APPLICATION NO.	FILING DATE	FIRST NAMED INVENTOR	ATTORNEY DOCKET NO.	CONFIRMATION NO.
10/680,716	10/06/2003	Tuoc Tan Nguyen	816020-100045-US	2647
34026	7590	04/19/2005	EXAMINER	
JONES DAY			MILLER, CHERYL L	
555 WEST FIFTH STREET, SUITE 4600			ART UNIT	
LOS ANGELES, CA 90013-1025			PAPER NUMBER	
			3738

Office Action Summary

DETAILED ACTION

Attachment # 1 (marked up)

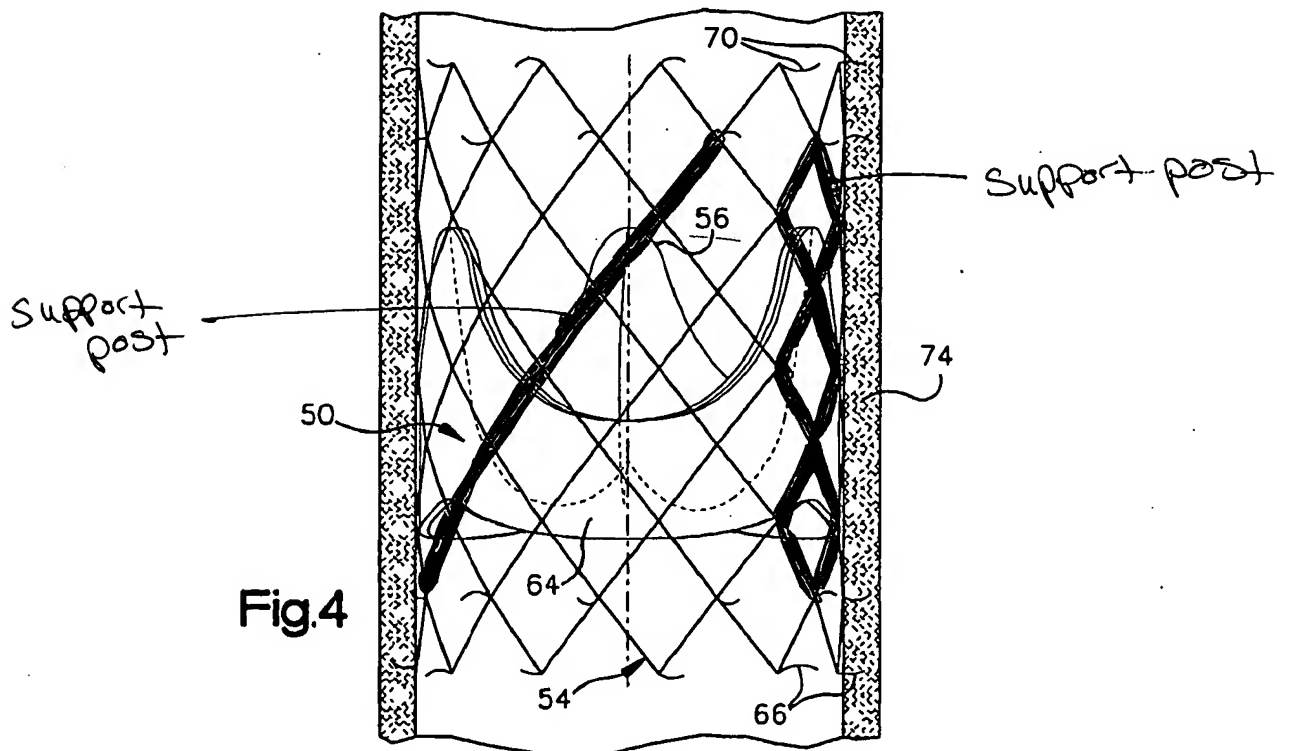
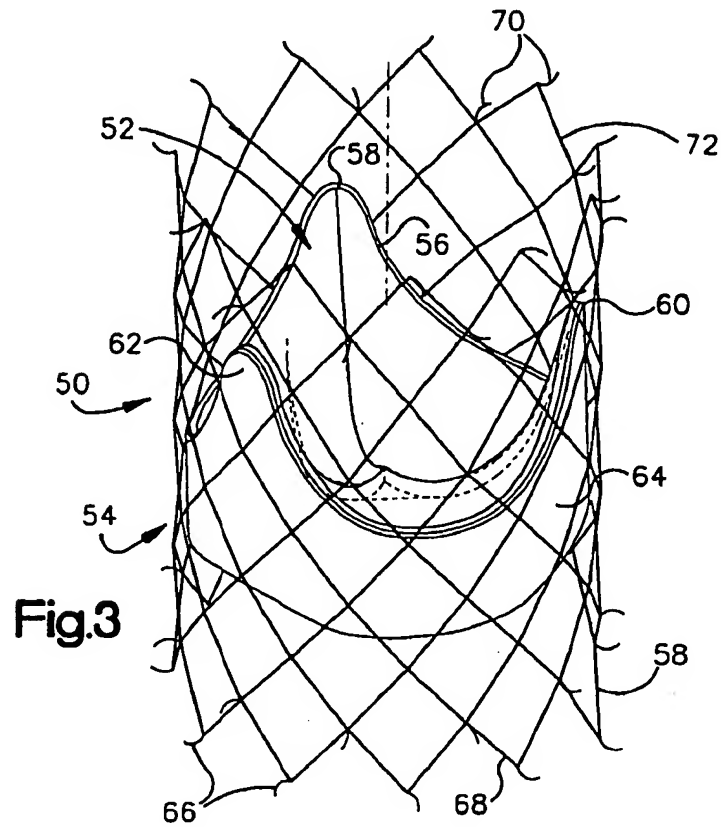
Claims 1-2 and 5-17 are rejected under 35 U.S.C. 102(e) as being anticipated by Gabbay (US 2003/0040792 A1). Gabbay discloses an assembly (fig.2, 4, 14, 18) comprising a replacement valve (12, 472, 590) having leaflets (22, 24, 26; 480) and a scalloped inflow annulus (inflow annulus is shown to be scalloped in all figures, but most clearly seen in figs. 1, 4, 15, 24) and an expandable anchoring structure (14, 420) having flared rims (see fig.15, 18, 14, 11, 2) and a plurality of support posts (any element seen in red in attachment 1) extending between the rims. Gabbay discloses the valve (12, 472, 590) to be positioned internal of the anchor structure (see figs). Gabbay discloses support posts to comprise a triangular window (attachment 1) *capable* of accommodating tabs. Gabbay discloses the support post to extend beyond the outflow rim (in the form of barbs 66, 70; see fig.3). Gabbay discloses the inflow rim of the anchor structure to have one or more rings in undulating patterns and the outflow rim to comprise one or more rings in an undulating pattern connected by a vertical element (see attachment 2).
